TORRINGTON AVE., PEAKS ISLAND 84-N-13

CITY OF PORTLAND, MAINE
Application for Permit to Install Wires

AP - Torrington Point, Peaks Island (87-11-13)

Examination of application for permit for alterations to dwelling at above named location and plans filed therewith raises the following questions about which more information is needed before a permit can be issued:-

Sunporch

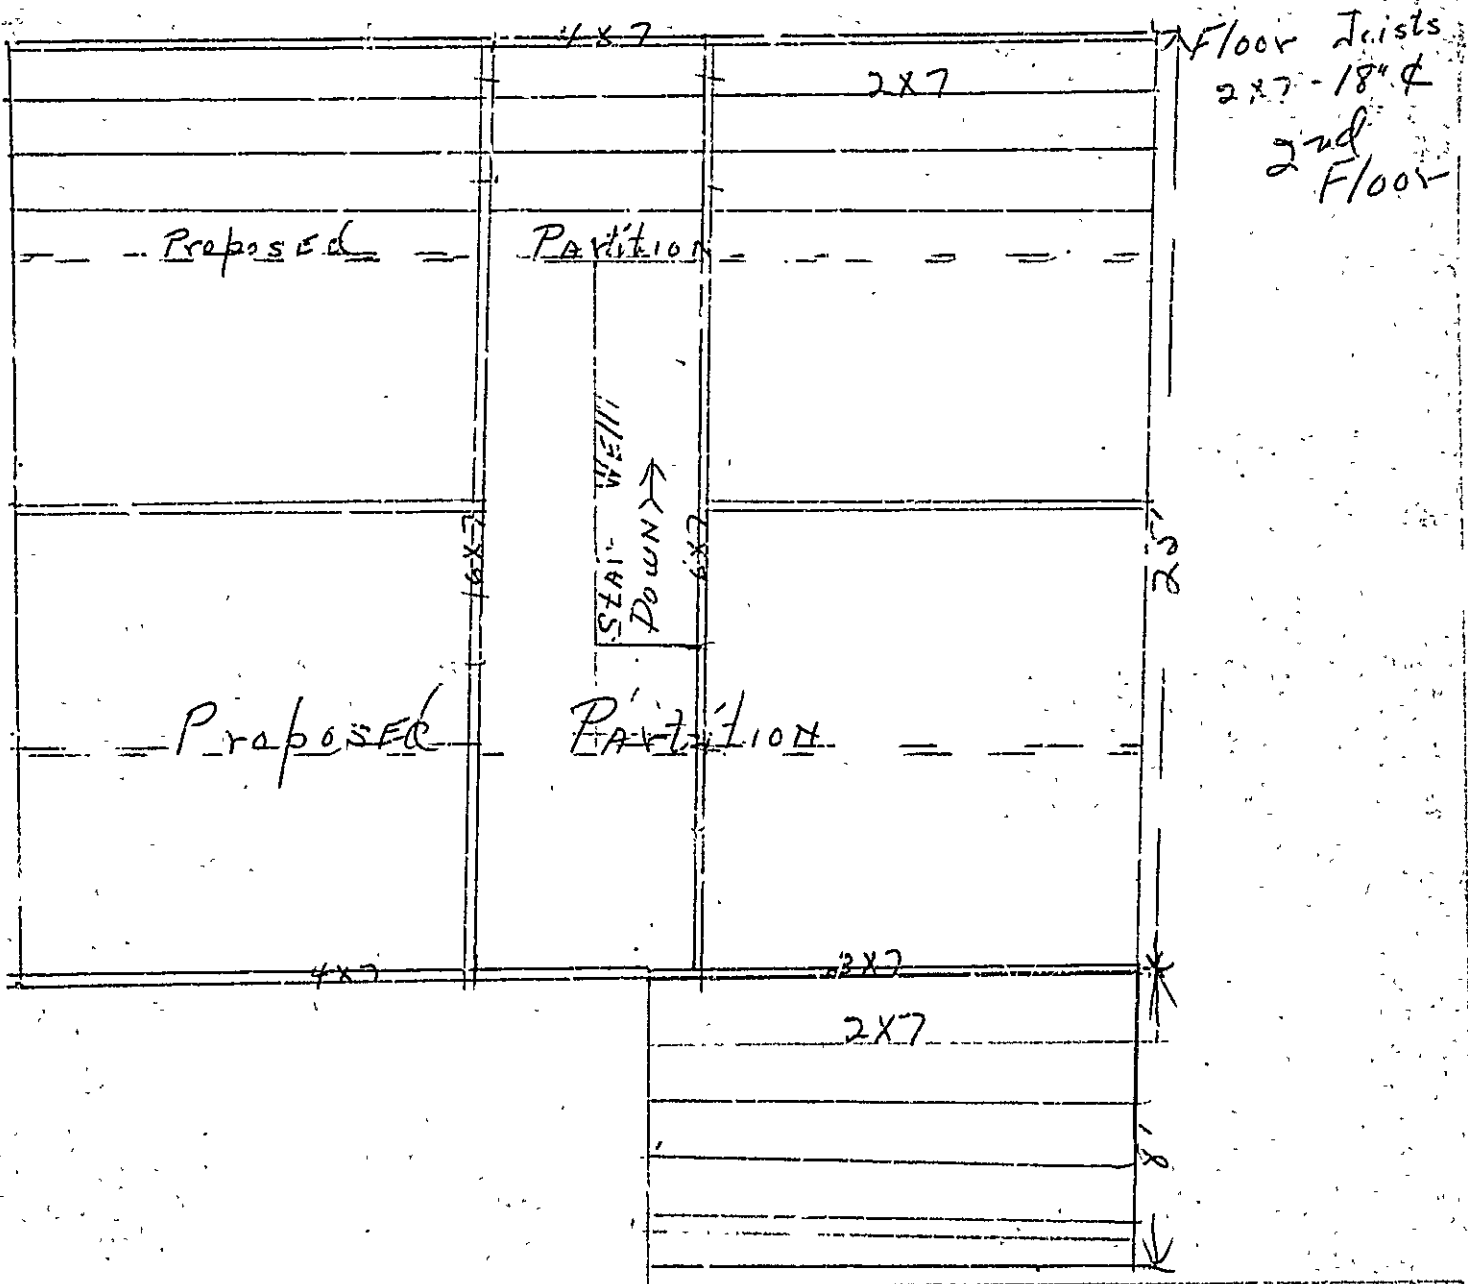
1. What is floor and roof framing of proposed sun porch to be? - O.K.
2. What is spacing of concrete piers at sun porch to be? - O.K.
3. Are there to be any large window openings in walls of sun porch requiring special size headers? If so, what is span and size of headers to be? - O.K.

6. What is framing of existing second floor?
7. Since the proposed sun porch is evidently to be an addition to the existing building, a plot plan showing distances to street and lot lines from new porch is needed.

South End View

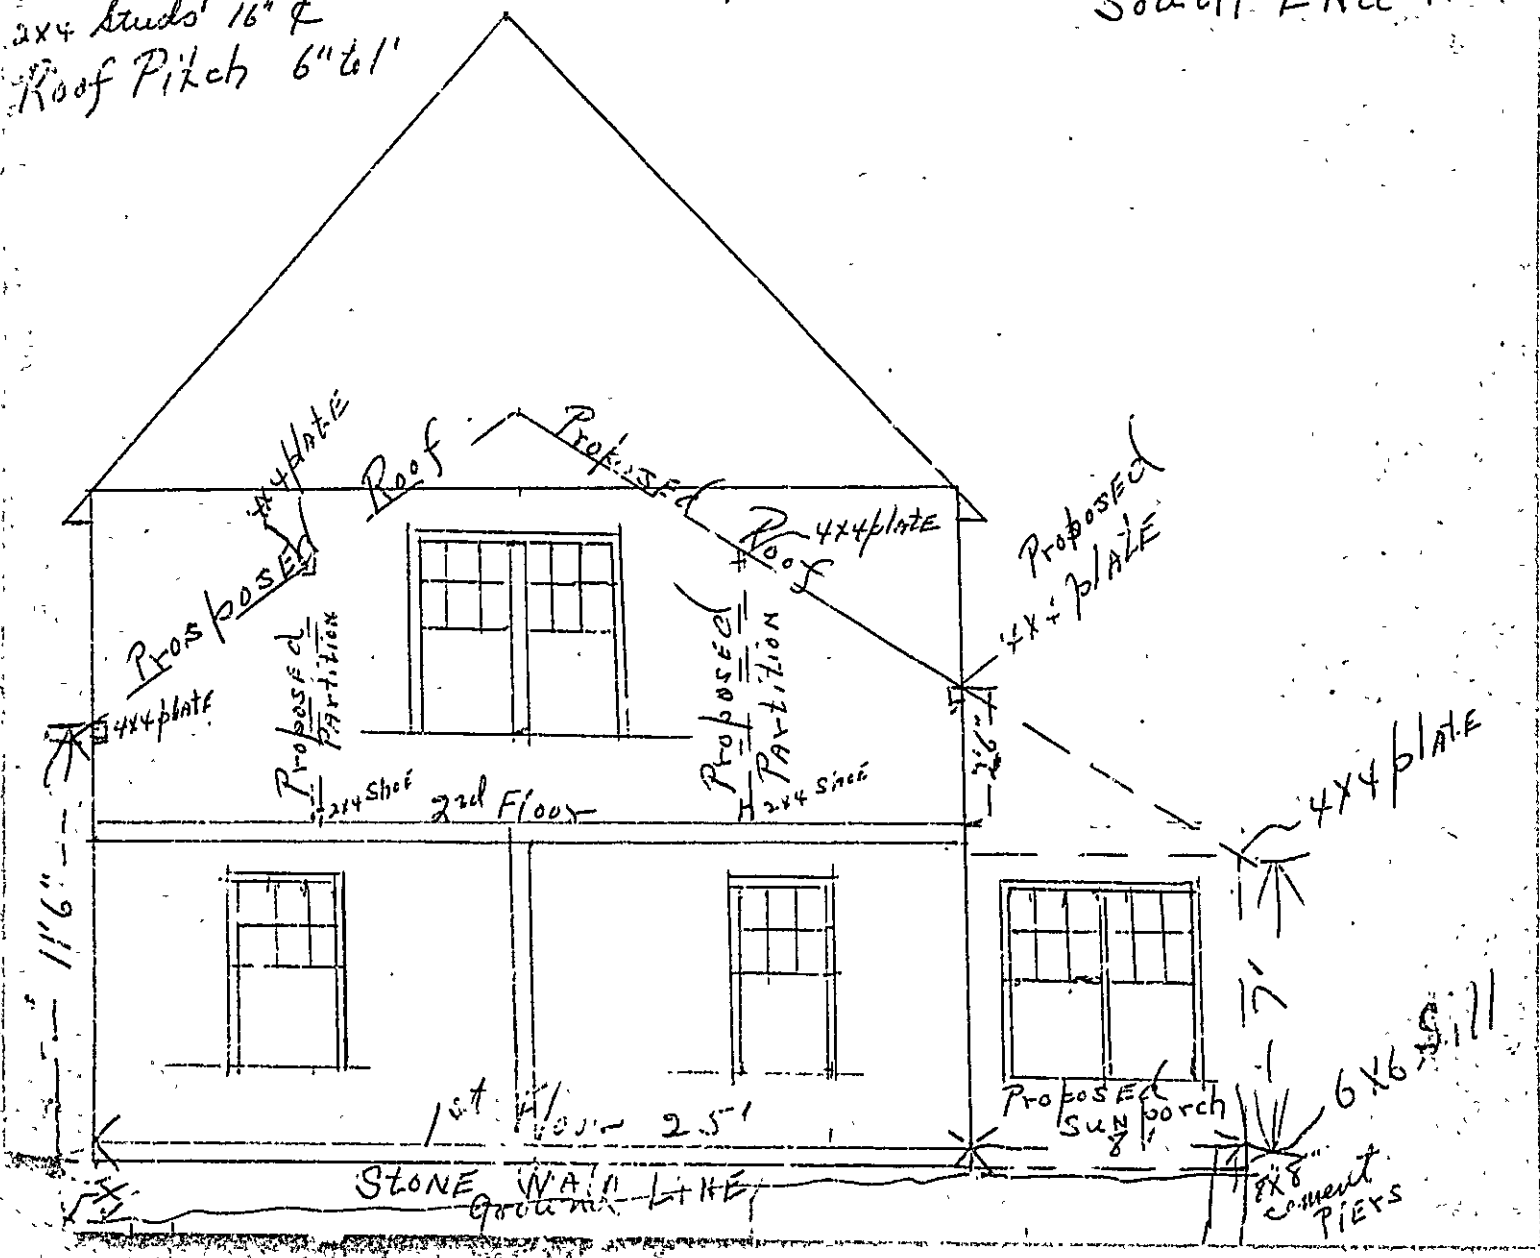
4. It appears that possibly the rear wall of building in first story adjoining two story rear shed is to be removed. If so, what size beam is to be provided to replace it? If not, what existing construction is there to carry the load across the opening?

5. Do the existing studs in outside walls extend in one length from sills to plates supporting rafters of existing roof, with second floor joists supported on ledger boards cut into the studs? If not, there will be a problem as to how a tie is to be provided across building to prevent spreading of walls at new plate level.

1. The new short walls on which new roof is to be supported, are to be tied back to the second floor timbers at intervals of not over 4 feet.
2. The new short wall across opening where part of kitchen projects into the rear ell beneath which there is evidently a 4x7 timber in second floor framing is to be braced so as to adequately support the load of the new roof coming upon it.
3. Second floor timbers beneath the new knee wall partitions in second story are to be doubled.
4. Presumably some sort of front entrance platform and steps will be needed, but are not mentioned in the application filed. This permit is therefore issued on the basis that before such a structure is built, an amendment to this permit covering the work will be secured.
5. Notification for a "closing-in" inspection will of course need to be given this department before any of new work is covered from view.

To change rafters on roof from 2 x 6 to 3 x 5 full size.
 To construct 4' x 6' front platform- 25' to street line.
